PERMIT

P 29335
A REPAIR

SEWAGE DISPOSAL SYSTEM

SUBDIVISION _____ ROAD 2634 Turf Valley Road LOT _____

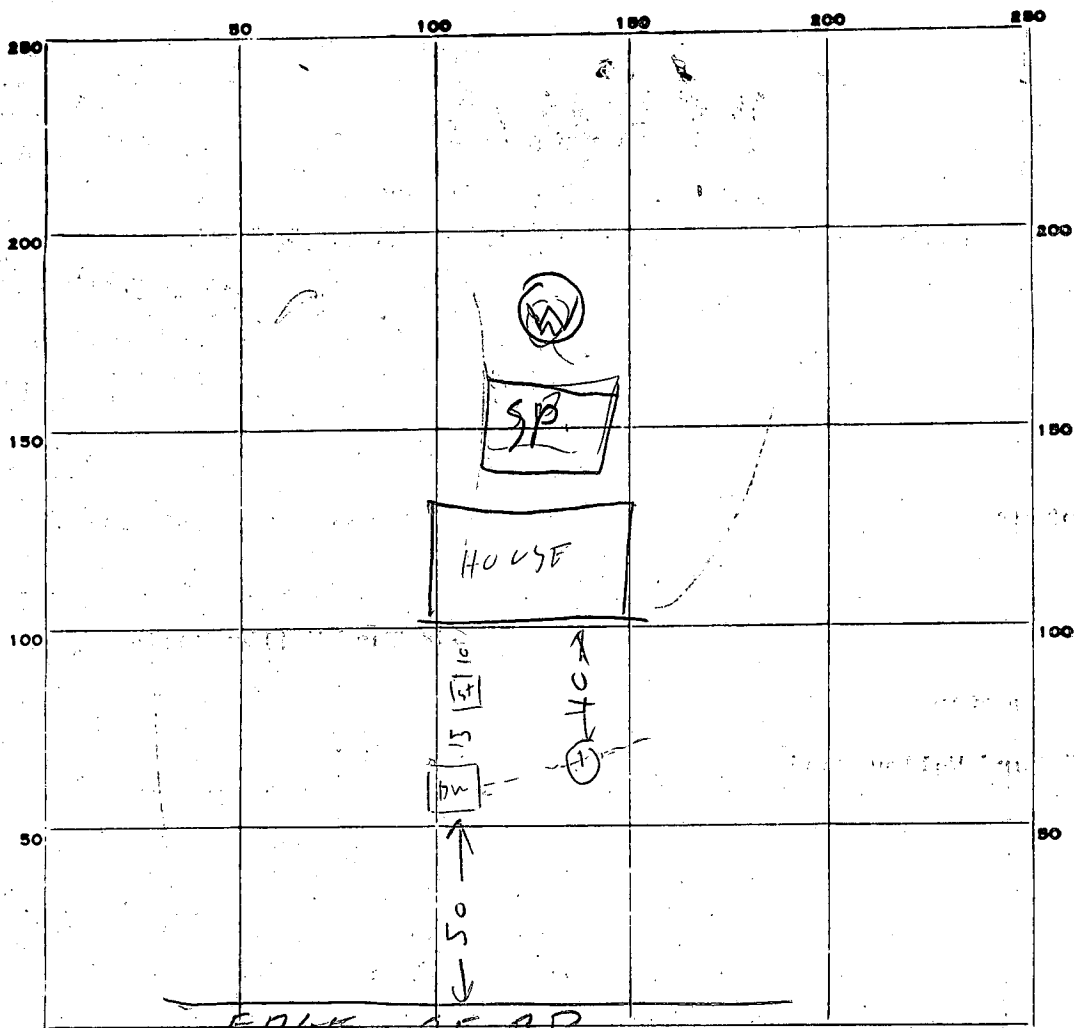
REMARKS Hole ① - TOP 3 FT CLAY BUT 8 FT SAND HARD SAND BOTTOM
OLD DW IN USE 13 YRS. & IS 16 FT DEEP INLET TO DW 5 FT
DEEP DW HIGHER THAN HOUSE ONLY POSSIBLE SYSTEM IS DEEP

DITCH OFF DW IF TREES ARE TO BE SAVED OR IF
12/18/78 solid rock 5 ft deep halfway in trench - advised against repair due
to poss. well cont. owner's wife said they would pump in rocks

REPAIR. 12/14/78 DEEP DITCH 12 FT DEEP 50 FT LONG 2 FT WIDE
FILLED WITH 5 FT OF STONE PLACE DITCH OFF
OLD DW & RUN IT TOWARD THE RIGHT SIDE OF THE
LOT AS SEEN WHEN FACING THE LOT

LOCATION SURVEY PLAT
 SUBJECT PROPERTY NOT LOCATED IN A FLOOD PLAIN AREA UNLESS OTHERWISE NOTED

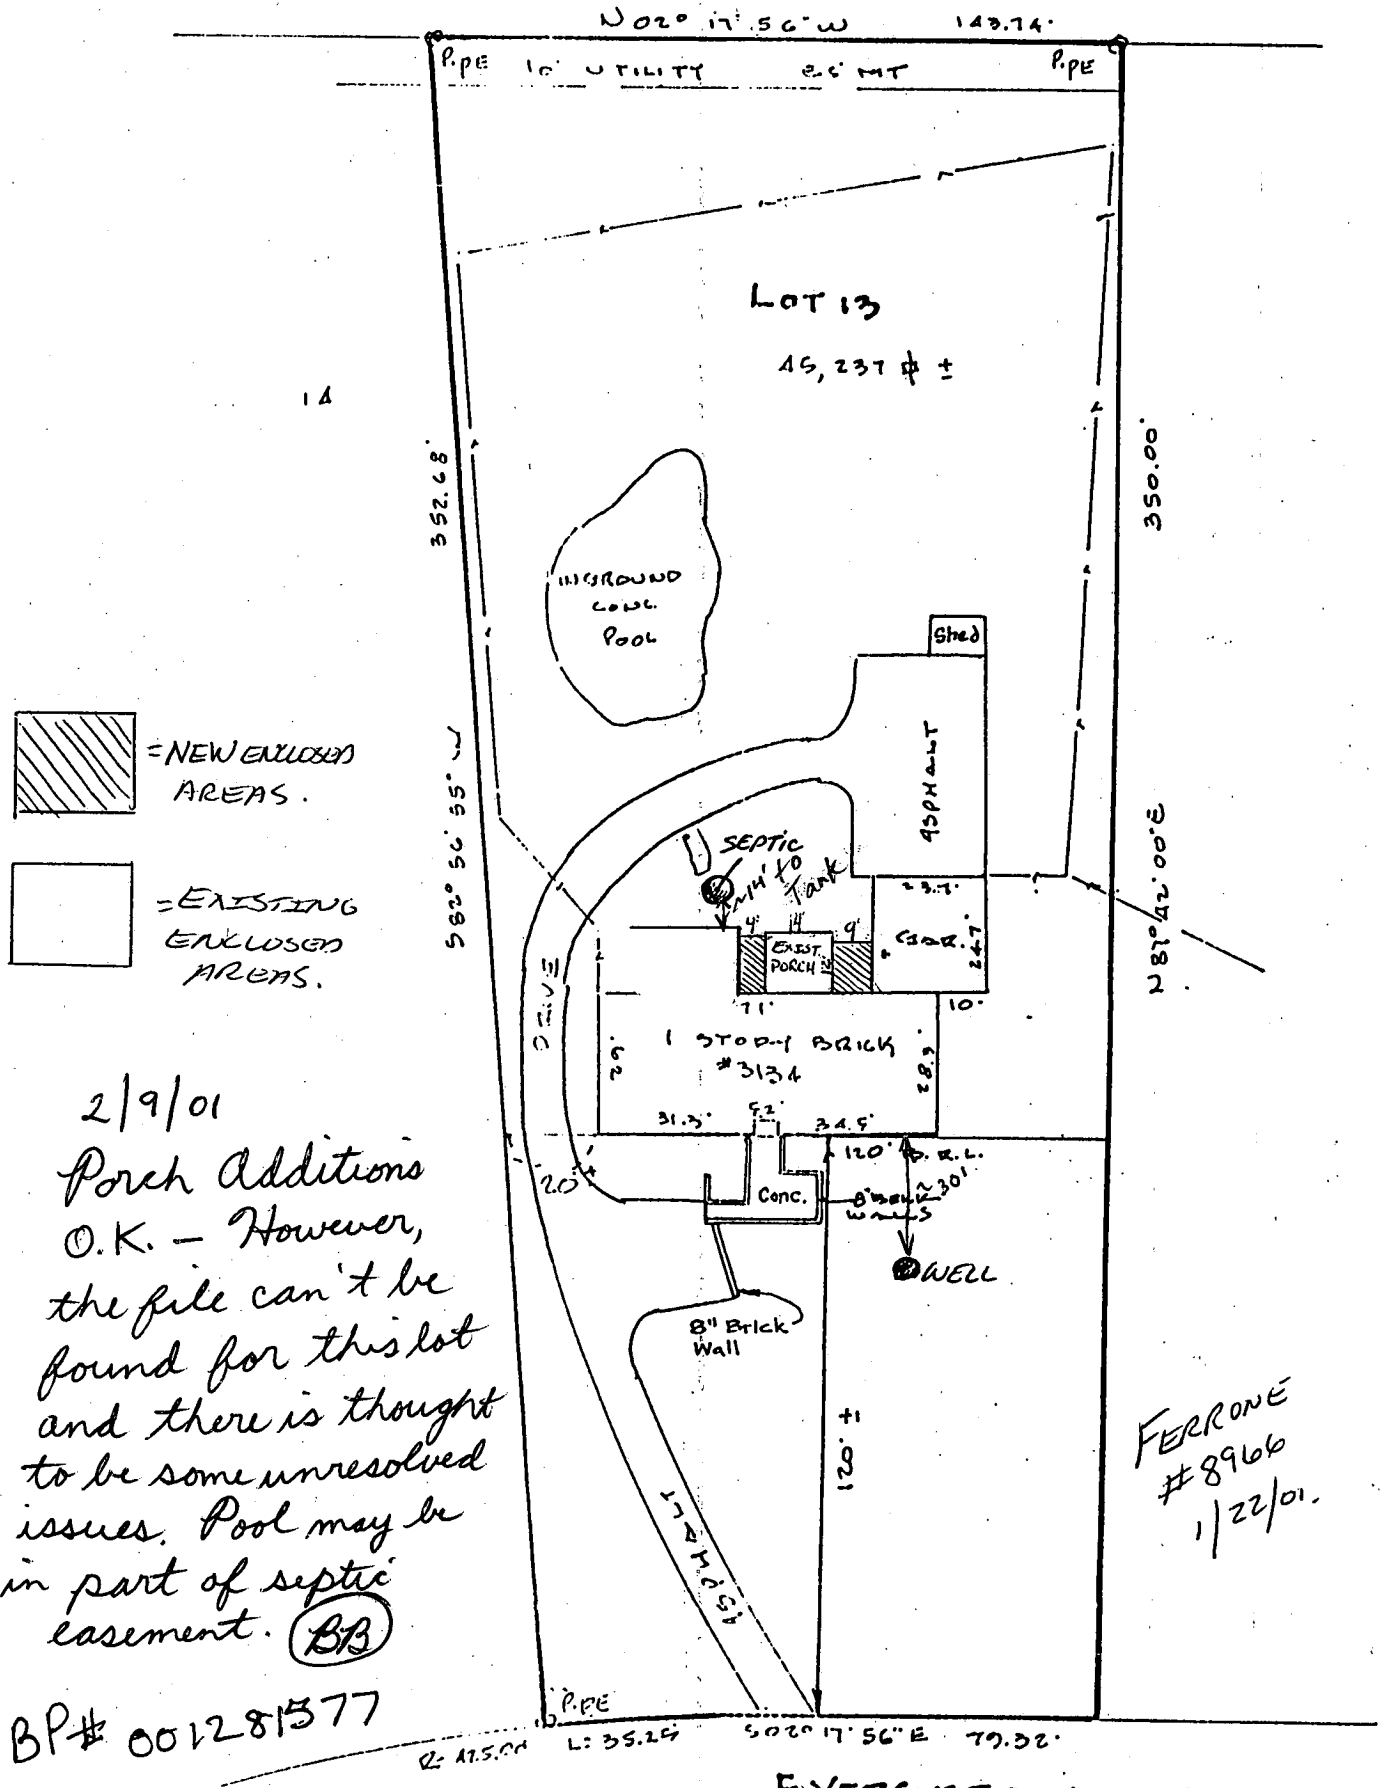
2/9/01
 Porch Additions
 O.K. - However,
 the file can't be
 found for this lot
 and there is thought
 to be some unresolved
 issues. Pool may be
 in part of septic
 easement. (BB)
